U.S. Department  
of Transportation  
**Federal Aviation  
Administration**

Subject: INFORMATION: Policy Statement on Corded Electrical  
Devices Used in the Passenger Cabin

<b>DISPOSITION OF PUBLIC COMMENTS ON DRAFT POLICY STATEMENT 02-115-20, CORDED ELECTRICAL DEVICES</b>	
<b>Commenter</b>	<b>Comment</b>	<b>Disposition</b>
General Aviation Manufacturers Association (GAMA)	<u>Passenger Injuries and Head Strike Consideration</u> Per the ARAC agreements regarding installations in airplanes which do not have Amendment 25-64 in their type certification basis, it was decided that seatback mounted items weighing less than 3 pounds would not require additional assessment for blunt trauma. As mentioned in the memo, they would have to be properly designed to ensure that no sharp edges or corners are exposed to the occupant seated behind the seat back. This option should be added to the Policy Statement.	This Policy Memo establishes an a compliance, but not the only mean
Cessna Aircraft Company	It is Cessna's belief that the Policy Statement No. ANM-02-115-02, Corded Electrical Devices, should only be applicable to Part 25 certificated aircraft with a passenger capacity more than 19.	The

# CORDED DEVICES

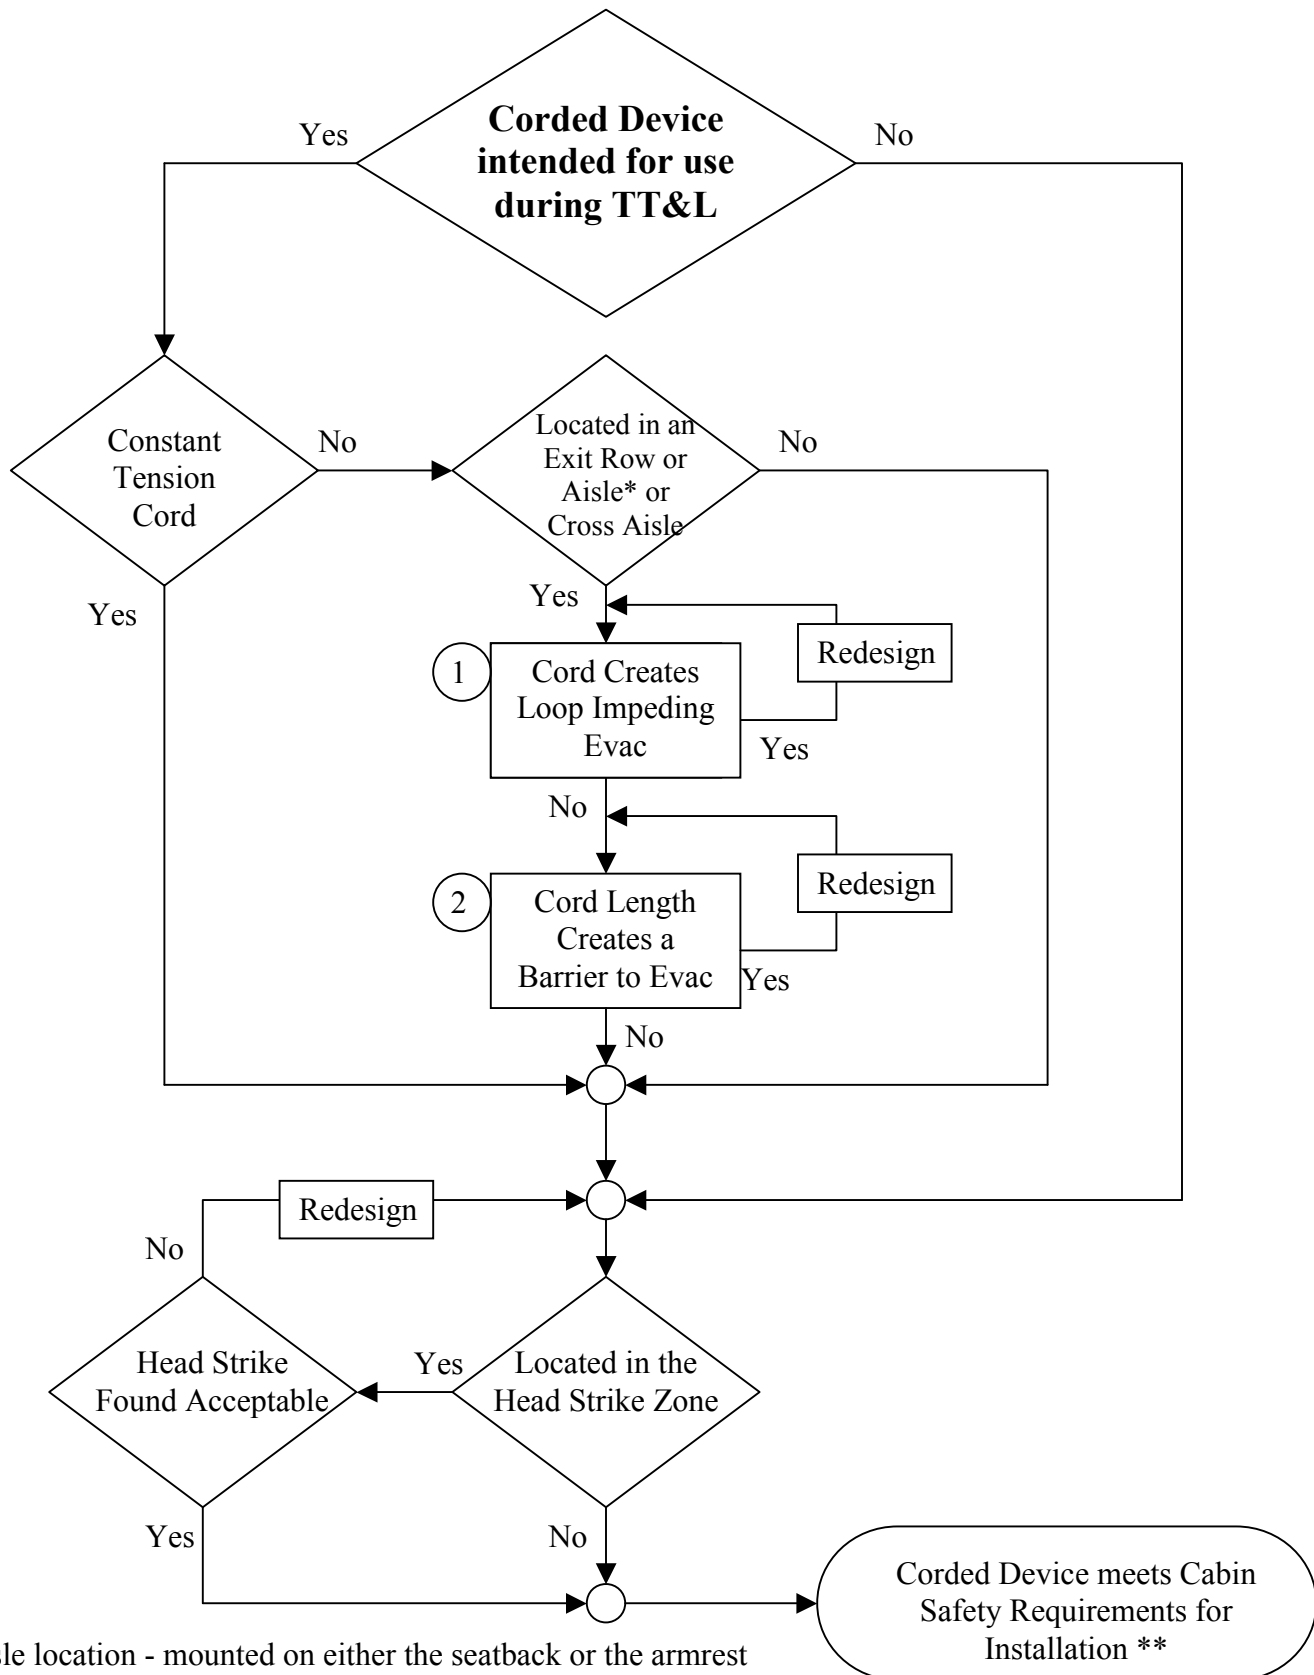
Boeing	Page 6, "Corded Devices" flow chart: Add the following information to the flow chart: If a modification (in production or post-production) to an existing certified interior configuration that includes corded devices is being done, and all of the following condition exist, then the cord devices do not need to be evaluated to the criteria in the policy memo, unless the design is as defined in Item d on page 3: There is no change to the seat part number; and There is no change to the IFE or telephone handset; and There is no change to the cord, cord reel equipment, or cradle: and There is no change to the installation of the handset / cord reel / or cradle in the seat.	It is the intent of this Policy to evaluate all configurations being installed either on a production certificate.
Boeing	Page 6, "Corded Devices" flow chart: Change the phrase in the diamond block that states " Located in an Exit Row or Aisle*" to state the following " Located in an Exit Row or Aisle* or Cross Aisle"	The statement has been revised.
